UNITED STATES PATENT AND TRADEMARK OFFICE

APPLICATION NO.	FILING DATE	FIRST NAMED INVENTOR	ATTORNEY DOCKET NO.	CONFIRMATION NO.
10/529,154	03/24/2005	Yoshihisa Umeno	10873.1582USWO	1870
52835 7590 10/16/2007 HAMRE, SCHUMANN, MUELLER & LARSON, P.C. P.O. BOX 2902 MINNEAPOLIS, MN 55402-0902			EXAMINER CORRIGAN, JOSEPH JAMES	
			ART UNIT 3744	PAPER NUMBER
			MAIL DATE 10/16/2007	DELIVERY MODE PAPER

Office Action Summary	Application No. 10/529,154	Applicant(s) UMENO, YOSHIHISA	
	Examiner Joseph Corrigan	Art Unit 3744

DETAILED ACTION

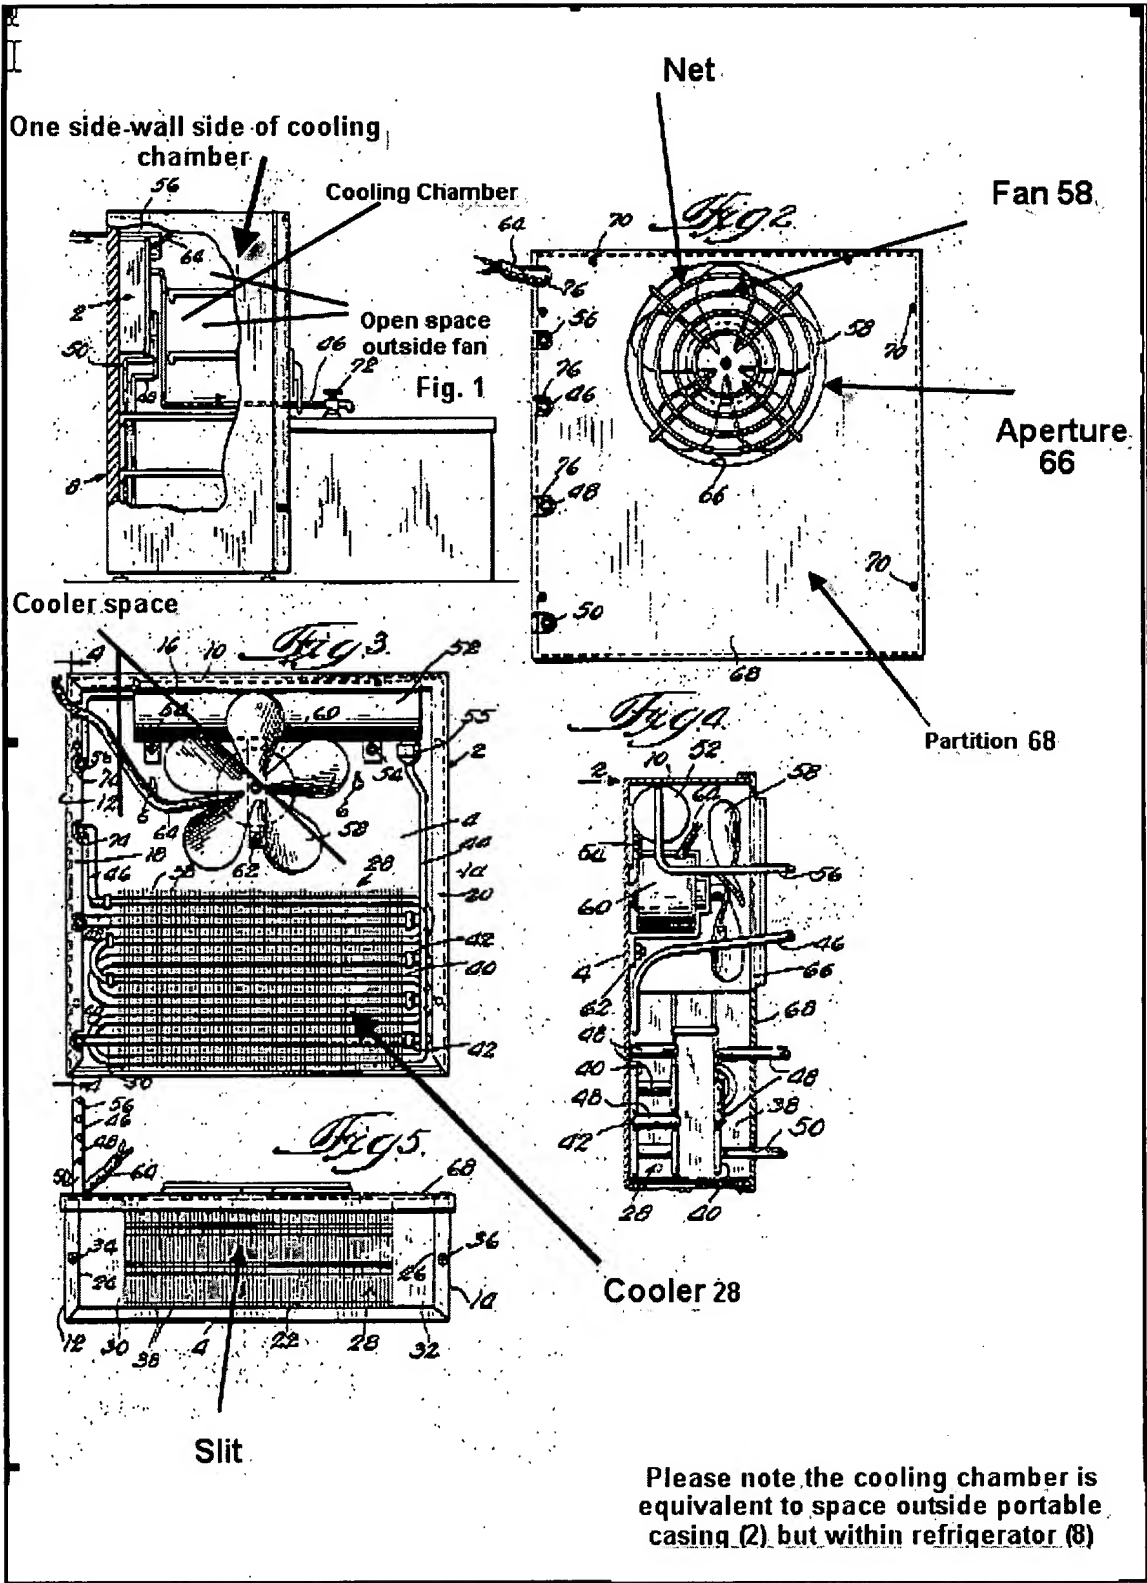
In re claim 1, J. H. Lazar discloses the claimed invention:

- A cooler (28) provided on at least one side-wall side (8A) of a chamber (see marked-up figure 1) formed with a thermally insulated box.
- A cooling chamber (see marked-up figure 1) in front of the cooler (28).

- A fan (58) that allows air in the cooling chamber (see marked-up figure 1) to flow.
(see figure 4)
- Wherein the cooler (28) and the cooling chamber (see marked-up fire 1) are partitioned by a partition (68) so as to allow cold air to be accumulated in the cooler (28).

- The fan (58) is disposed on a side of a cooler (28) relative to the partition (68).
(see figure 4)
- The partition (68) in front of the fan (58) has an aperture (66) formed in the flat sheet portion. (see figures 1 & 4)

- An open space (see marked-up figure 1) is formed between the fan (58) and the flat sheet portion (partition and bottom portion of cooler casing) in which the aperture (66) is formed (see figs. 2 and 4).

- Cold air accumulated in a space inside the partition (68) and hot air in the cooling chamber (see marked-up figure 1) are exchanged by the fan (58) through the aperture (66). Since applicant does not specifically define in claim language airflow in terms of an implied or explicit restriction to contribution from the evaporator section, an "elevator" type circular flow meets the claim limitation. In other words, since "hot air" originating in cooling chamber gets drawn up through the bottom opening (slot) in cooler casing and out through the aperture, ultimately blending the hot and cold air. Broadly speaking one can surmise by using the applicants phrasing "exchanging by the fan through the aperture" being the most dynamic segment of the mixing cycle.

In re to claim 3, J. H. Lazar discloses in fig. 4 that when viewing the fan (58) in a direction of a rotation shaft of the fan (58), the fan (58) is disposed in the aperture (66) and there is an open space (see marked up figure 1) outside the fan (58).

In re claim 8, J. H. Lazar discloses that a slit is formed in the partition (68) at a portion opposed to the cooler (28) or a portion below the cooler (28). Broadly recited, a "slit" (see marked-up drawing 5) is an opening, and thus, Lazar teaches a slit.

In re to claim 10, J. H. Lazar discloses that a safety cover (see marked-up drawing 2) is disposed over the aperture (66) using a net (see marked up figure 2).

Scofield Patent # 2,957,067

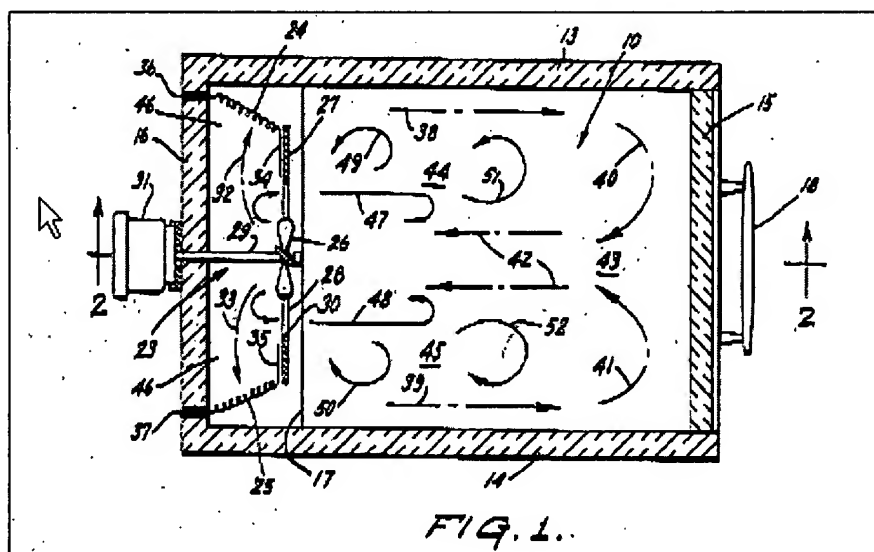
Scofield teaches (fig.1 above) and in column 4, lines 13-27 "[using an oversized fan aperture 28] "..... In normal operation the air of said streams is reasonably hot [cold], although such air may be slightly cooler [warmer] than the air of forward currents 38,39, the thermal gradient being due to inherent and unavoidable radiation of heat (cold) from the extended surfaces of flat oven (10) [refrigerator]. It will thus be seen that returning or short-circuiting airflows (47,48) contribute substantially to the desired affect of additional heating [cooling] to areas 44,45 into which they circulate.

In addition, the introduction of such return currents 47, 48 causes added heating [cooling] of said areas 44, 45 and consequently, satisfactory heat (cold) equalization between all oven [refrigerated] areas, by the inherent creation of eddies 49, 50, 51, 52

along the boundaries of counter current air flows 47, 38 and 48, 39. Such eddies deflect heated [cooled] air, of maximum [minimum] temperature, from the currents 38, 39 which flow alongside walls 13, 14, and the deflected hot [cold] air is then diffused by such eddies in areas 44, 45. Thus the jet-like and compact form of said hot [cold] air currents 38, 39 is largely destroyed and there is created, in effect, the equivalence of an air guiding and distributing structure, in the area receiving heated [cooled] air, equivalence being provided by the mere employment of oversize fan aperture 28, in the area wherefrom air is supplied by the heaters [cooler]."

It would have been obvious to one of ordinary skill in the art at the time of the invention was made to modify Lazar with teaching of "oversized fan aperture" structure to generate airflow dynamics in cooling chamber. ***This airflow signature in its purest form approaches an ideal three-dimensional heat gradient for cooking or cooling {value(ideal) = zero}, not unlike how multi colored ingredients in a blender become one. Temperature gradient turbulence dynamics, irrespective of its place in the heat spectrum correlates one to one up and down the heat scale, thereby satisfying airflow requirement presented by applicant.*** It would be advantageous to create eddy currents in that it stalls to to the extent that the colder air is distributed more uniformly keeping all products be cooled at the same low temperature.

In re claim 5, D. W. Scofield (see fig. 1) teaches that using an oversized fan aperture one can create eddy currents, to in effect, "... deflect heated air ... ", as stated in column 4, line 18, which is analogous to suppressing flow speed of cool air in a cooling system.
